CCK-2979.00-1-26

UK North Farm Seedhouse

ADDENDUM #4

UK Project #: 2979.0 Seedhouse

M800

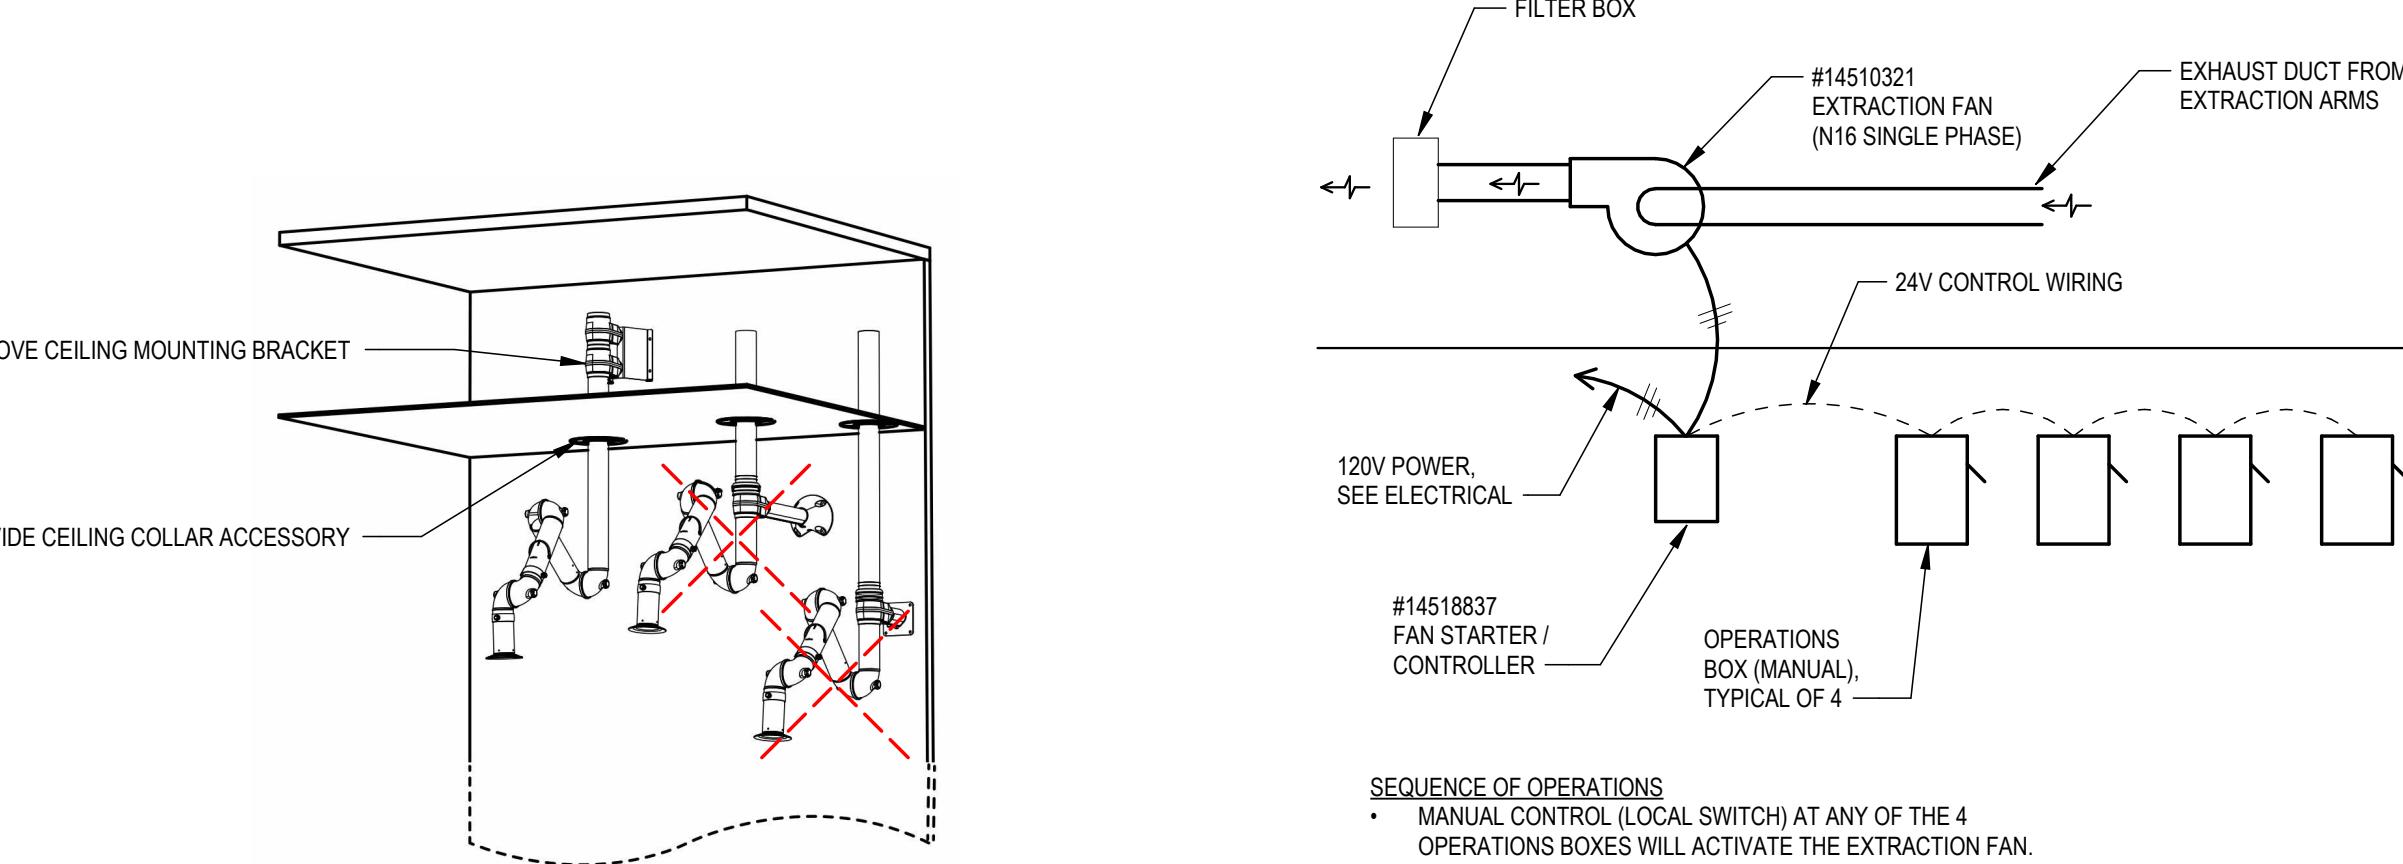
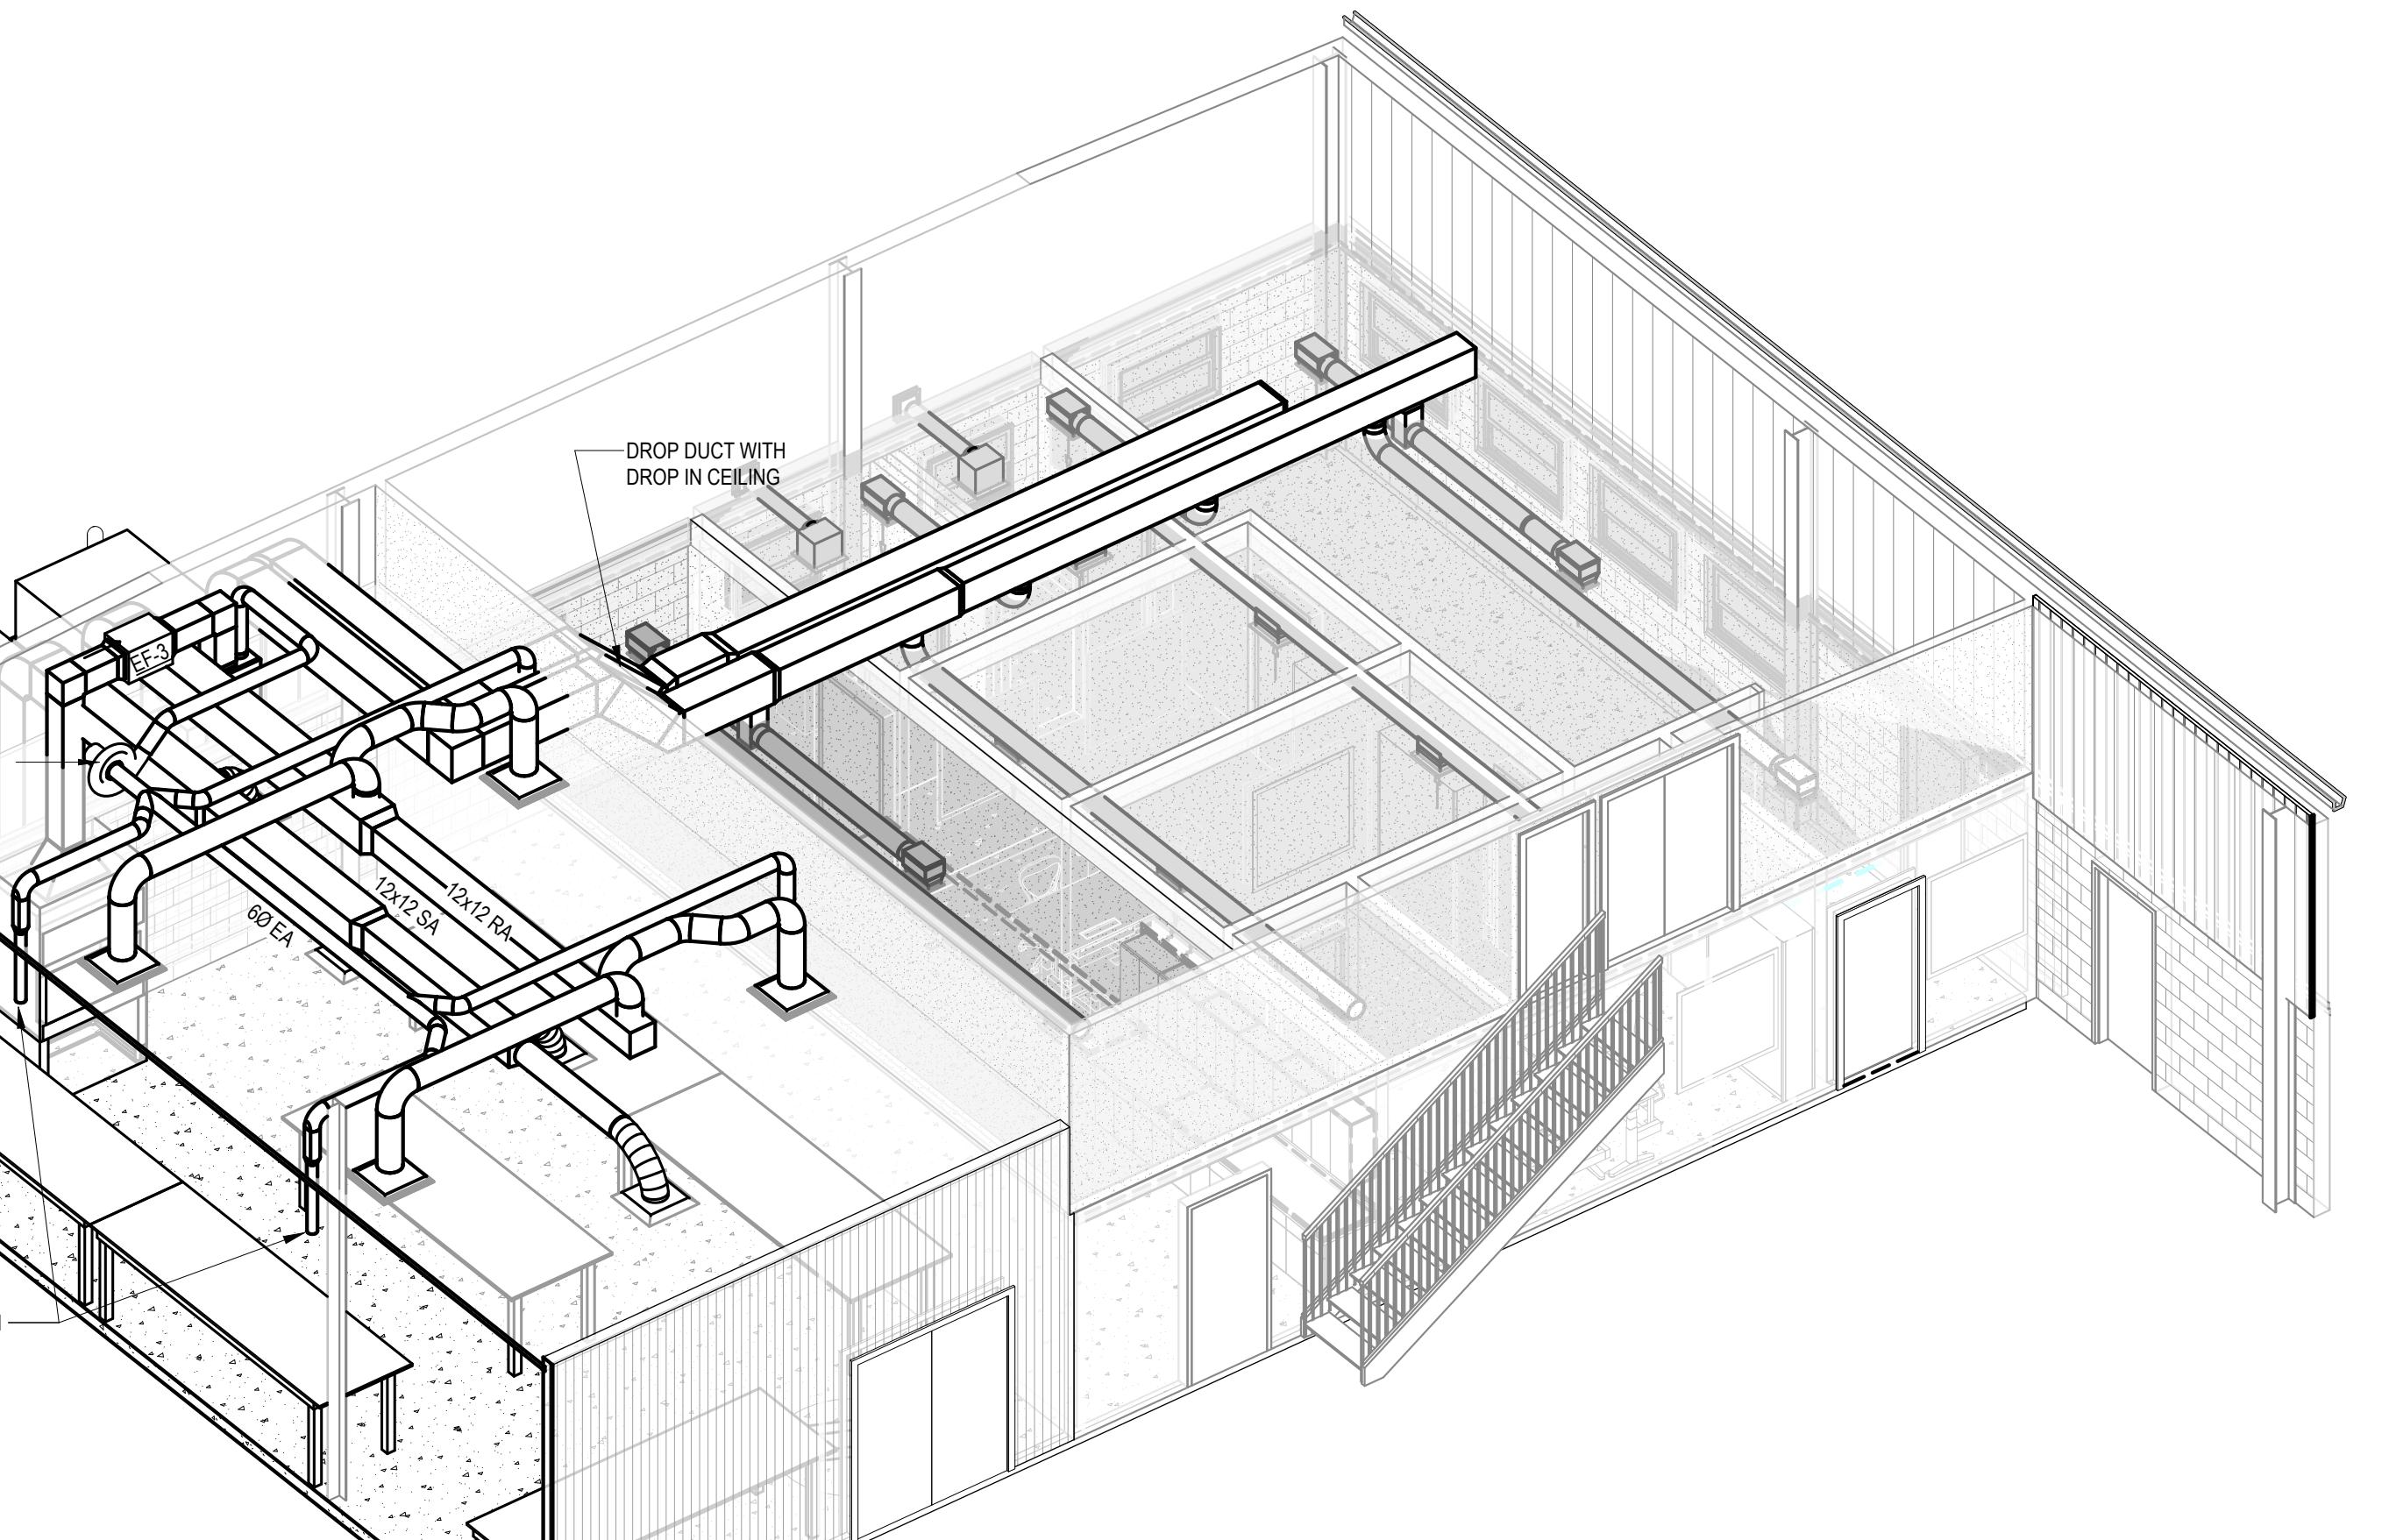
10. See revised RTU Schedule on sheet M-800.
11. See revised Fan schedule on sheet M-800.
12. See revised Electrical sheets in response to bidder questions.
